BID Addendum-01

Project No.
JCDT23-0185

Title
Bid Clarification 01

Project Name
St Clair County Heath Dept Relocation

220 Fort Street
Port Huron, MI
48060
Drawing Title
**SOUTH WING - LEVEL 1
HVAC PLAN**

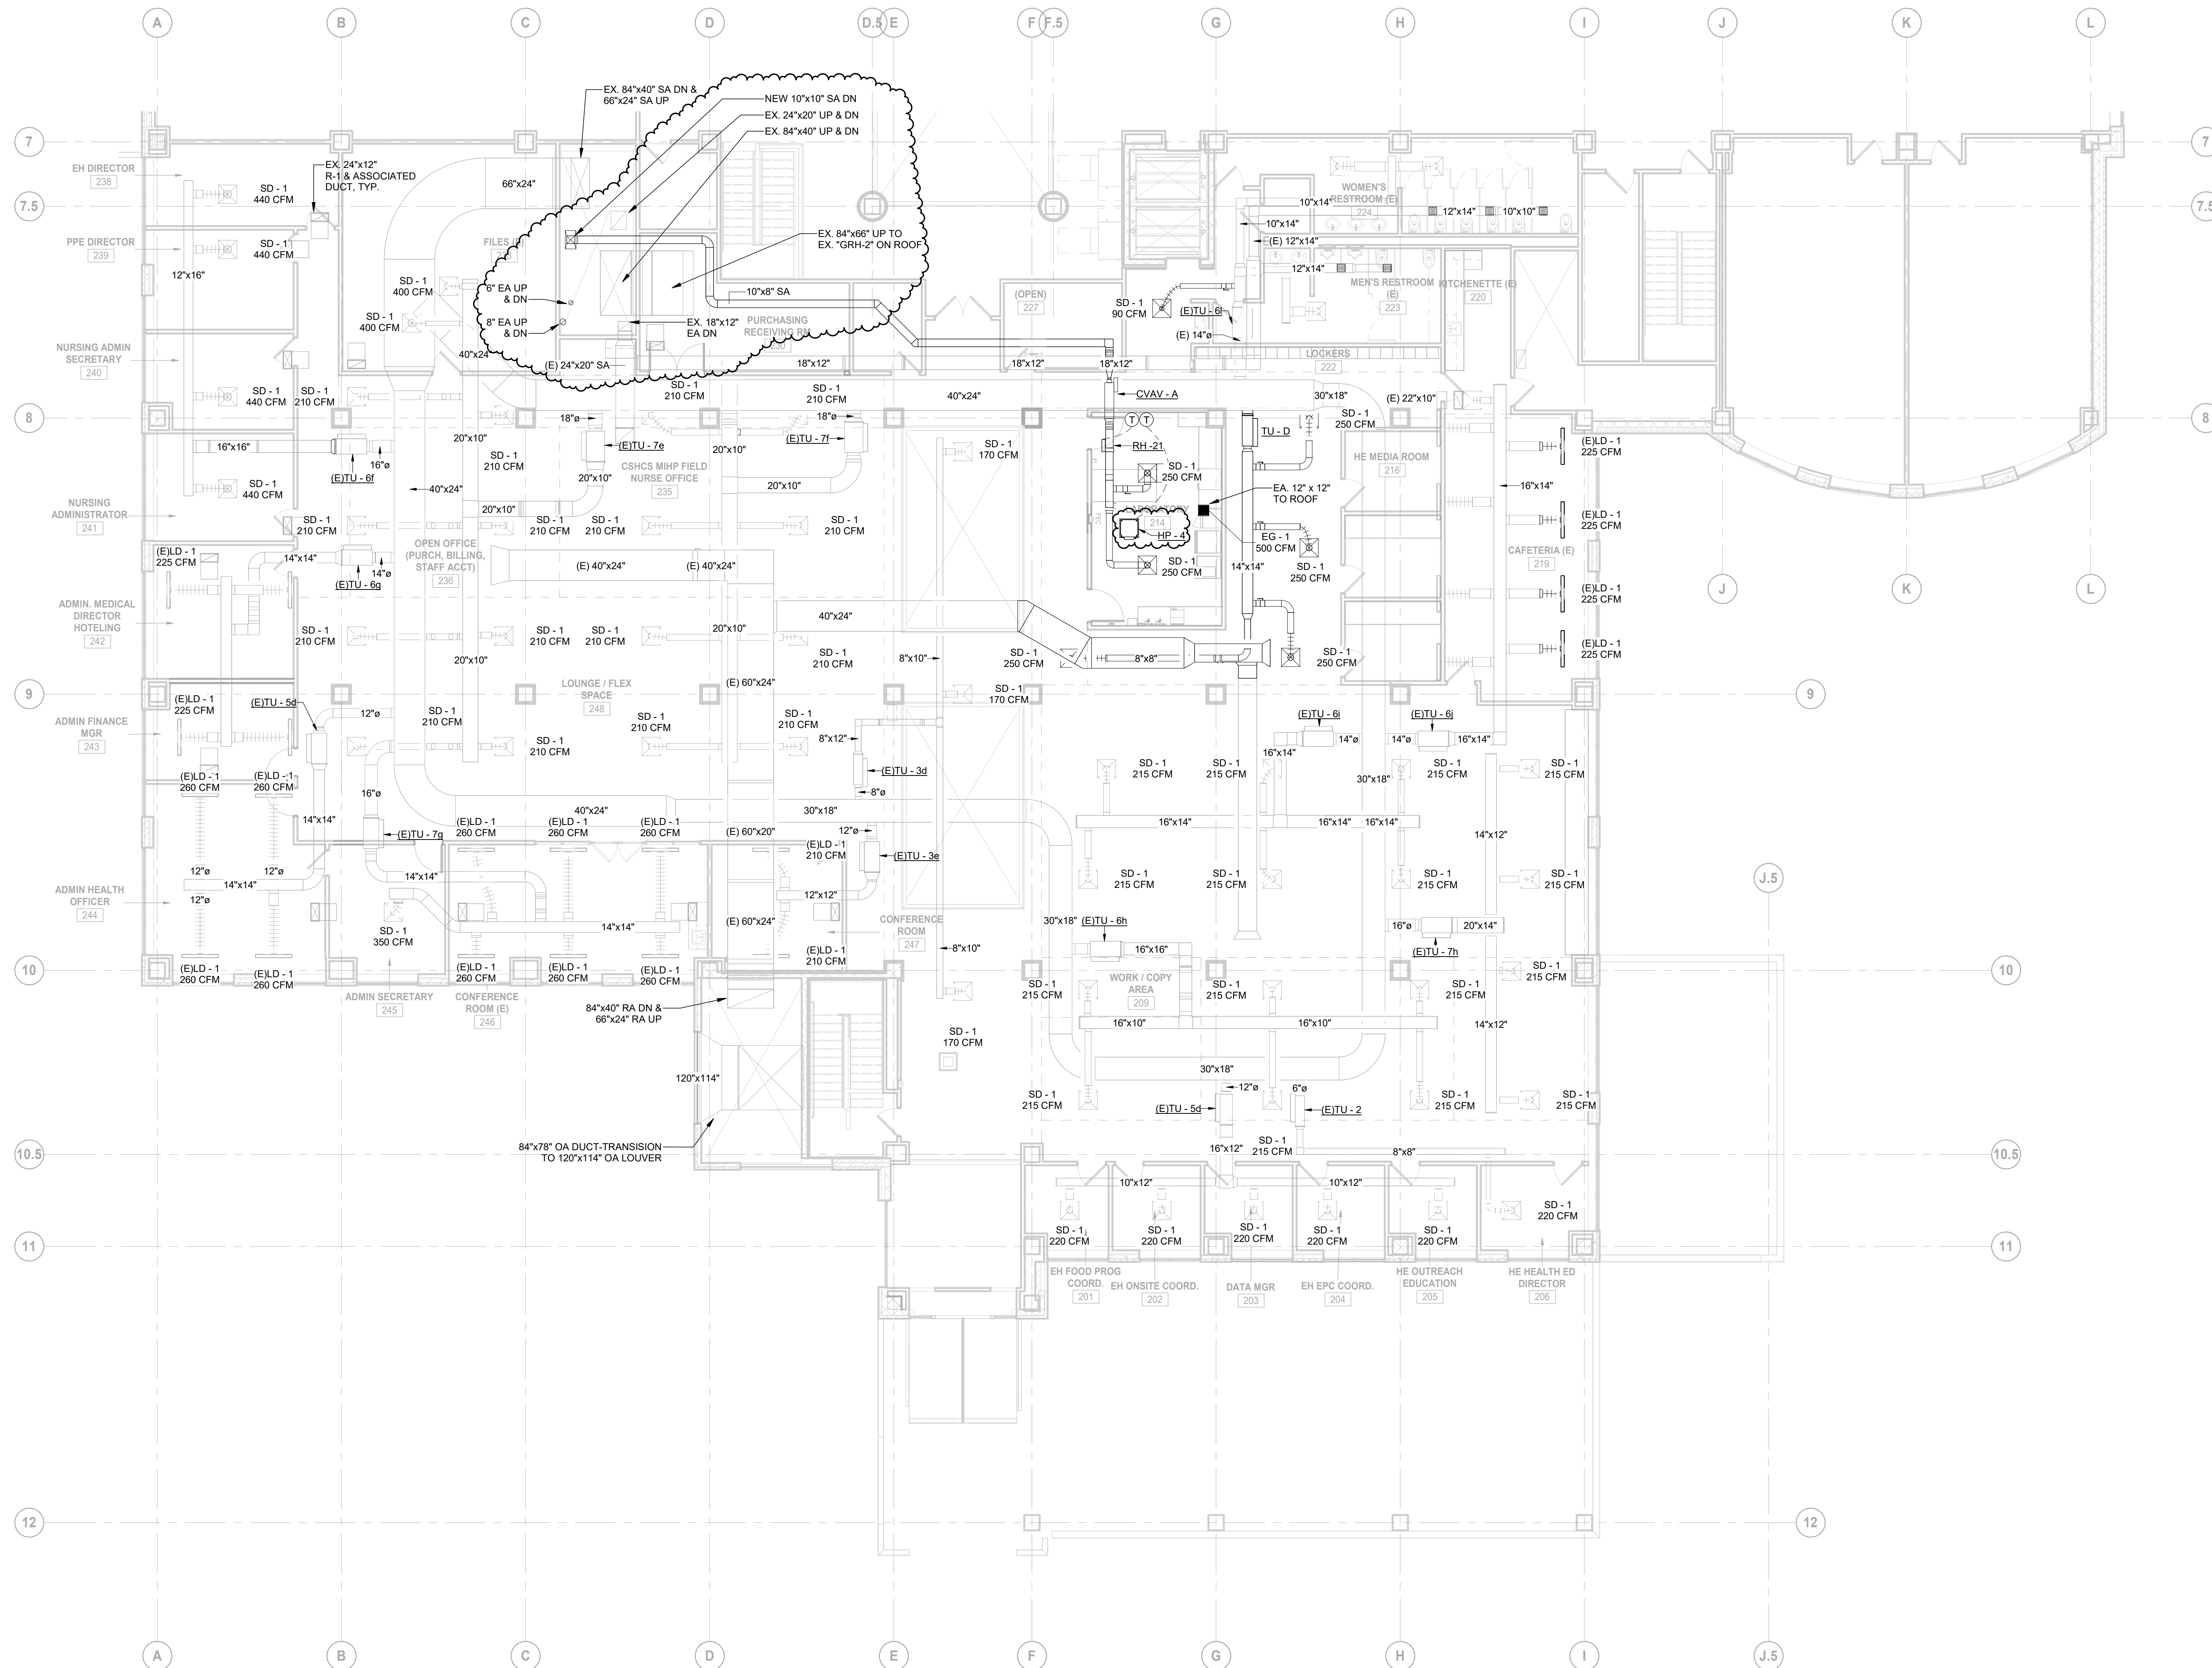
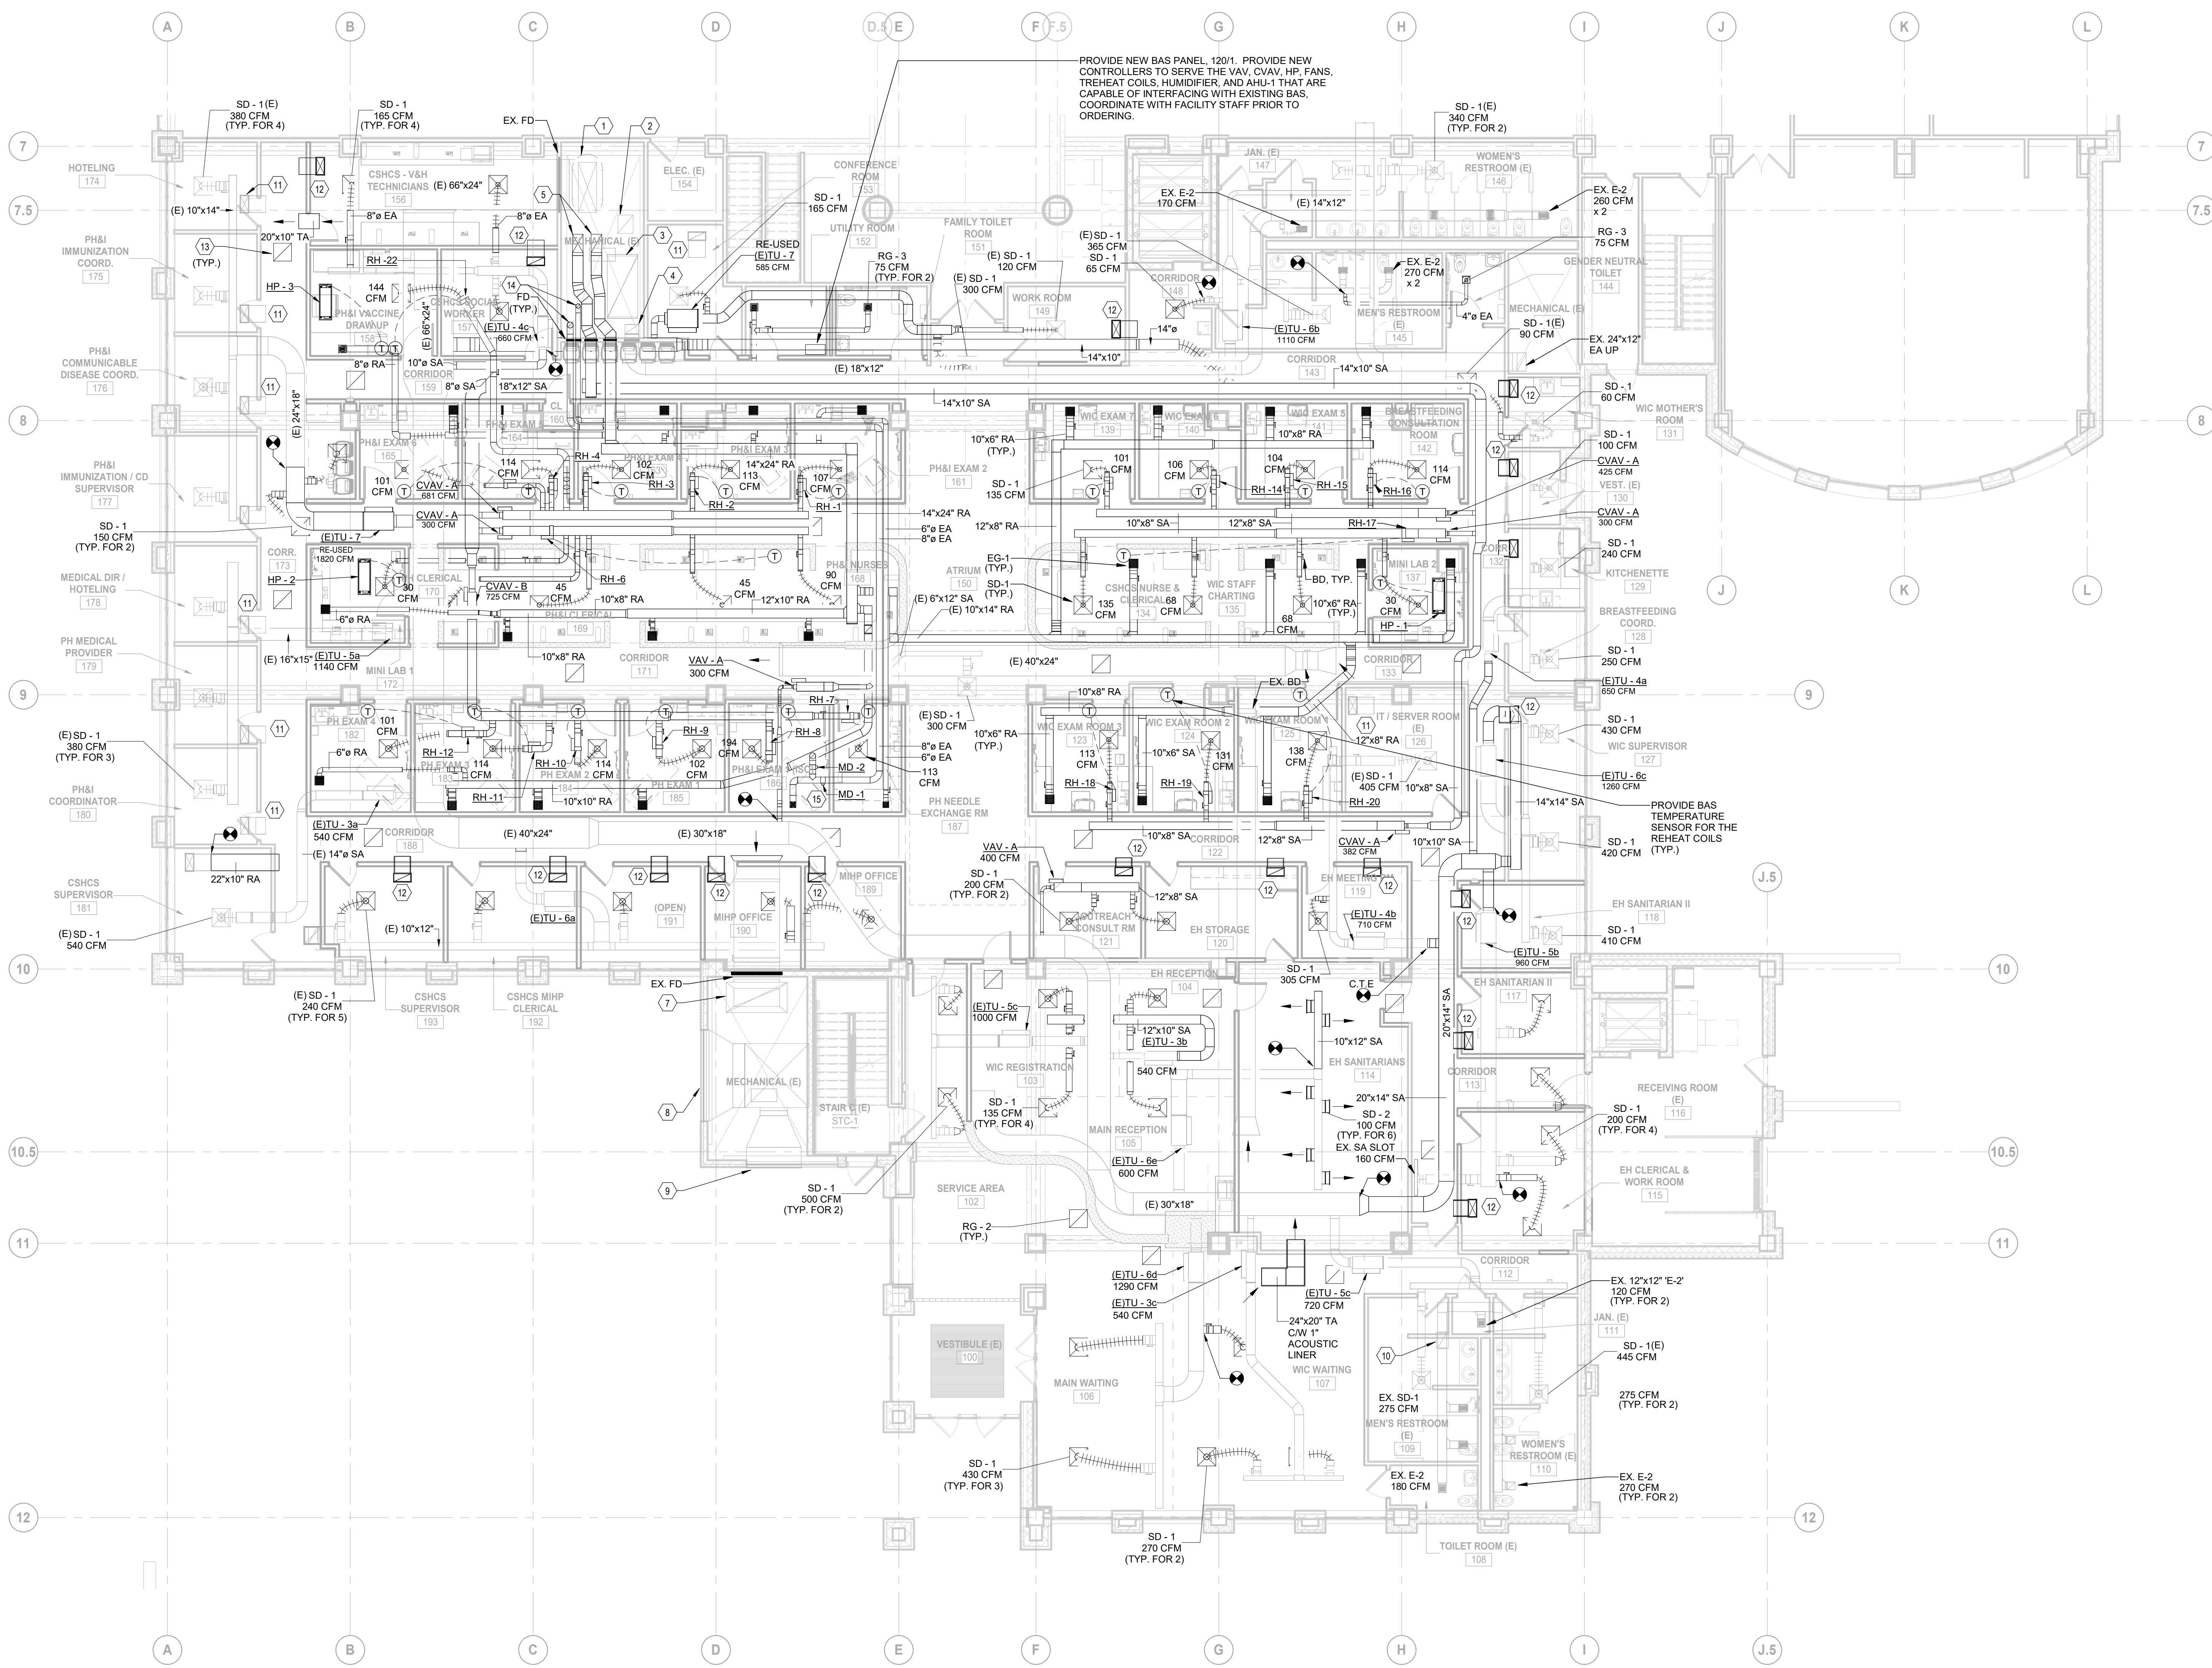
11. Dwg No M50-01
 - a. HP-1,2,3 updated to show ceiling recessed modules.
 - b. Exhaust air ductwork included in labs and vaccine draw up. Routed to roof exhaust fans.

- c. Airflow included on perimeter tags
 - d. Duct reheaters tagged on plan
 - e. Transfer ductwork added to rooms 121, 120, and 119.
 - f. PH&I EXAM 1 (ISO) ductwork revised.

- g. Added Thermostats in the healthcare exam rooms and associated rooms.
12. Dwg No M50-02
 - a. HP-4 updated to show ceiling recessed module.
 - b. Exhaust ductwork included for laboratory 214. Routed to rooftop exhaust fan.

Drawing Title
SOUTH WING - LEVEL 2 HVAC PLAN

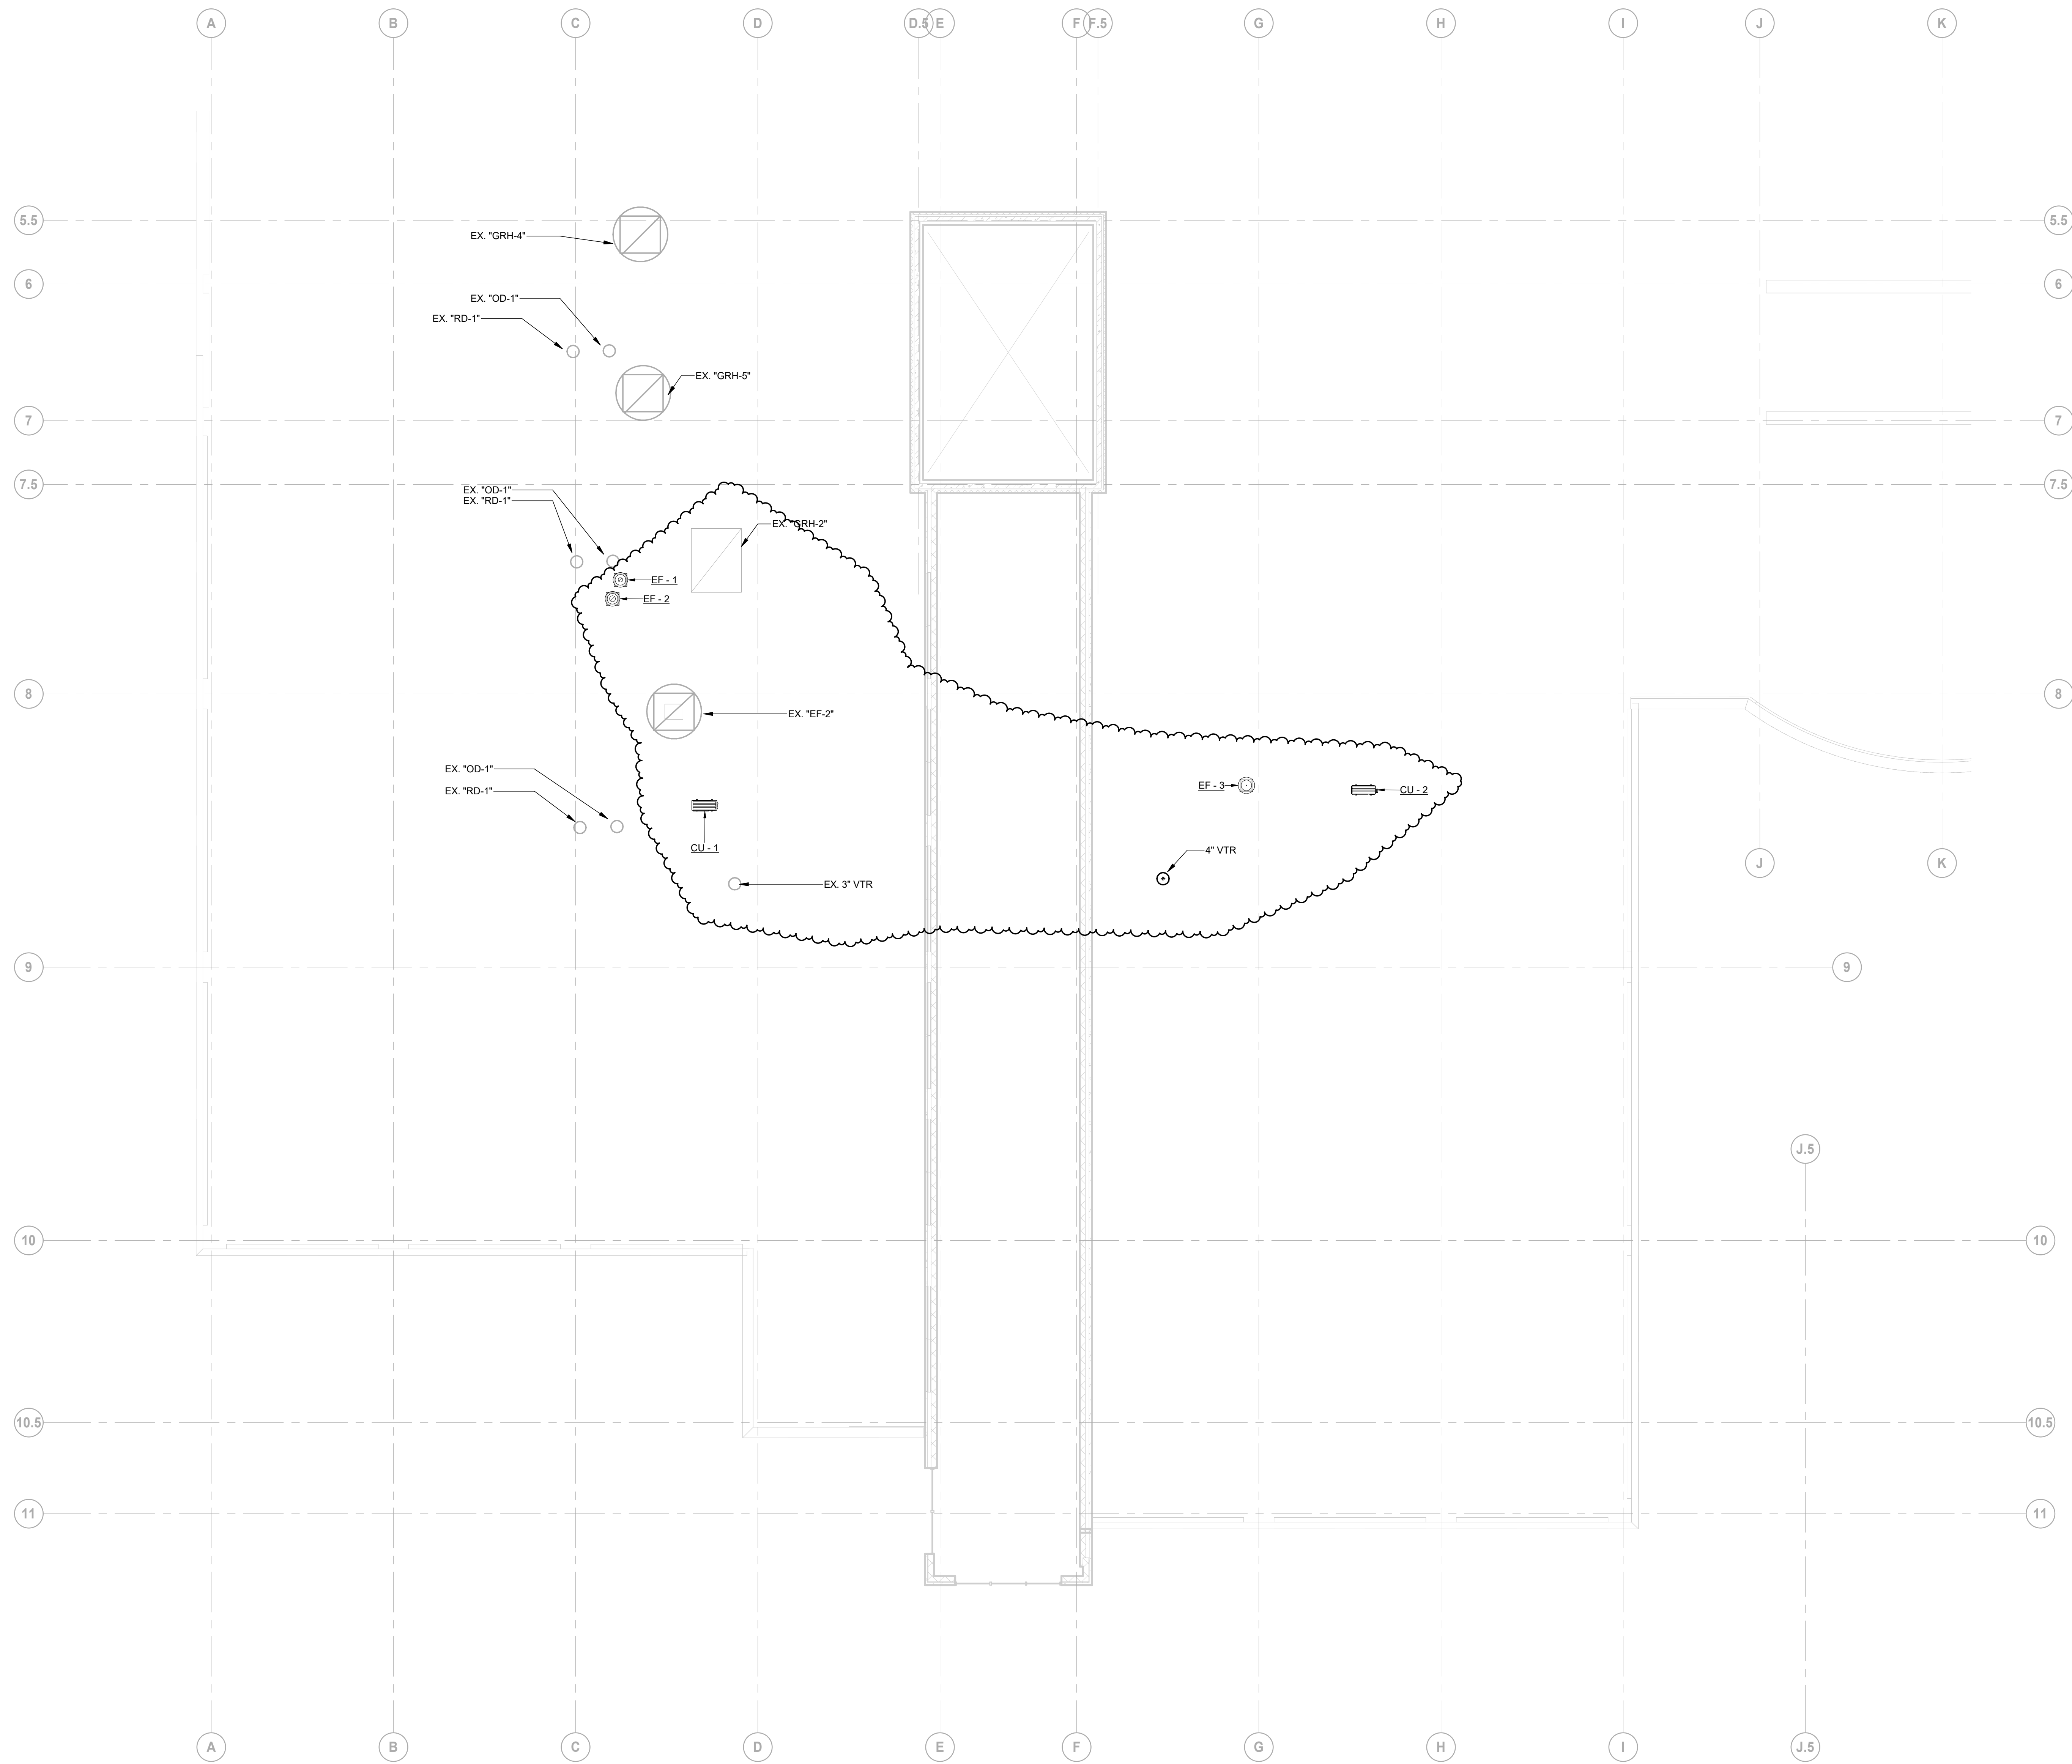
- c. CAVV-A included for supply ductwork to laboratory 214.
 - d. Added thermostats.
13. Dwg No M50-03
 - a. Added CU-1,2 to rooftop plan.
 - b. Added EF-1,2,3 to rooftop plan
